National Highways Authority of India

19001/1/RO-W-UP/NH-30/Ch. 278.543/NOC/786

Dated: 30.06.2021

Sub: Proposal for NOC for access permission to the proposed fuel station of M/s Indian Oil Corporation Limited on NH-30 (Old NH-24) in km. 279 (Ch. 278.543, RHS) at Village-Bakarganj, Tehsil-Faridpur & District-Bareilly in the State of Uttar Pradesh.

In view of the above, a copy of Drawing (Layout and Drainage Plan) as approved by the Competent Authority is being enclosed herewith for taking necessary action.

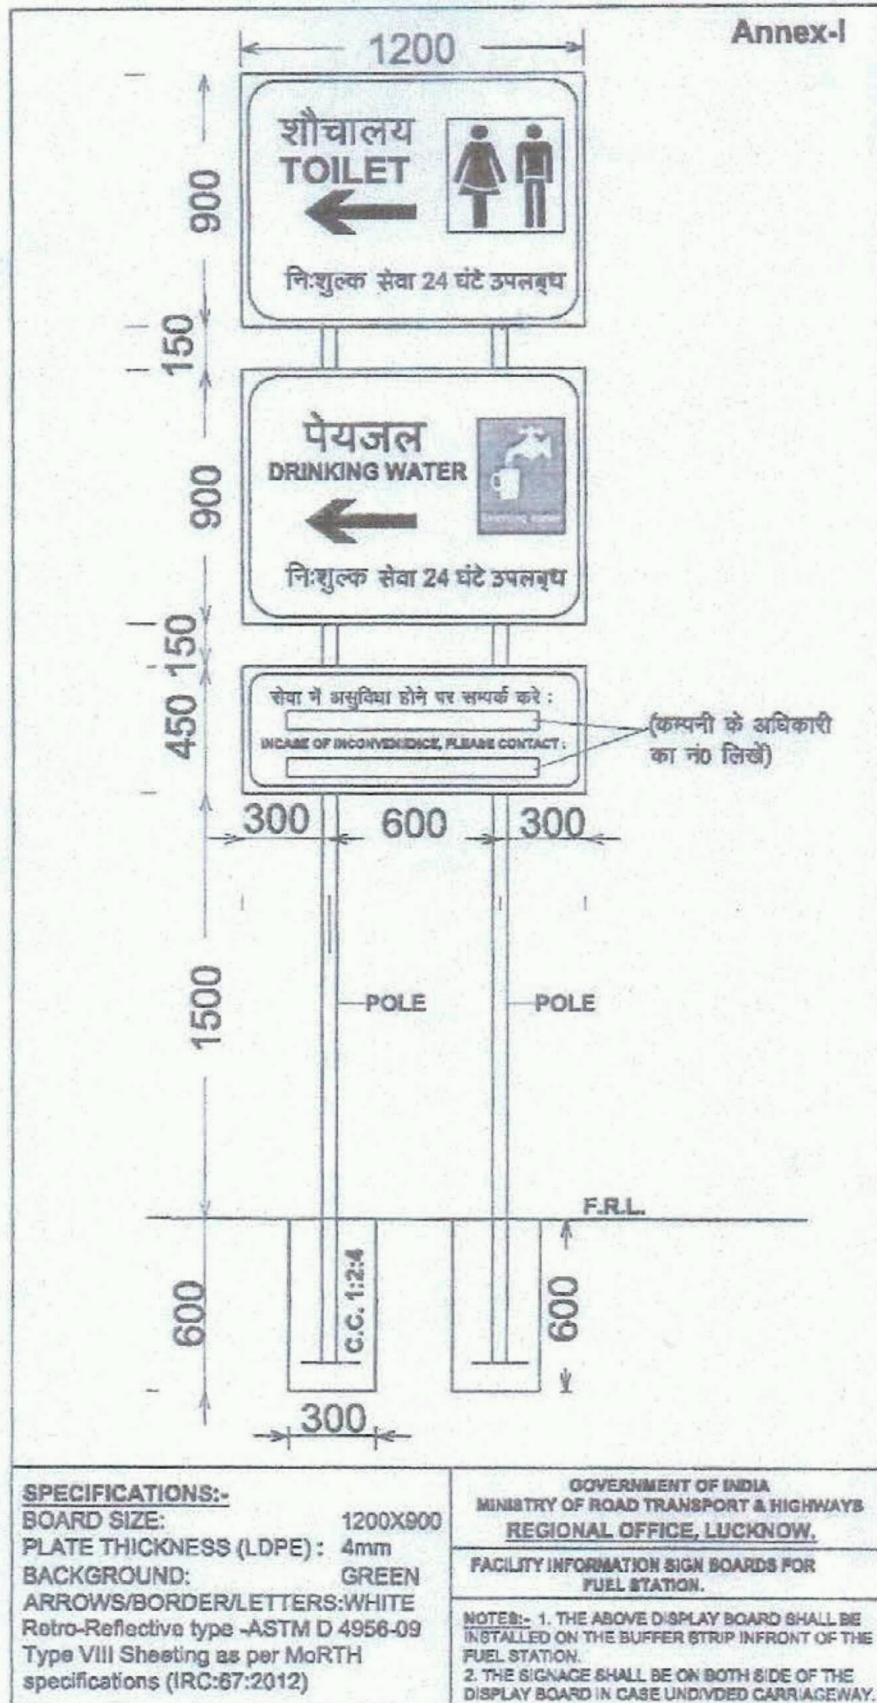
- (iv) For drainage, RCC slab culvert with minimum span of 2m shall be provided as per IRC: SP: 13-2004 - "Guidelines for the design of small bridges and culverts". The slab culvert shall be constructed with iron grating of adequate strength in the approaches for drainage of surface water. It must be ensured that outfall of above said culverts shall be led away to a natural course/outfall sewer through culvert or led away to a water-recharging system specifically constructed by the owner/management of the retail outlet/facility in case lined drains of sufficient length upto a natural course/outfall sewer are not available.
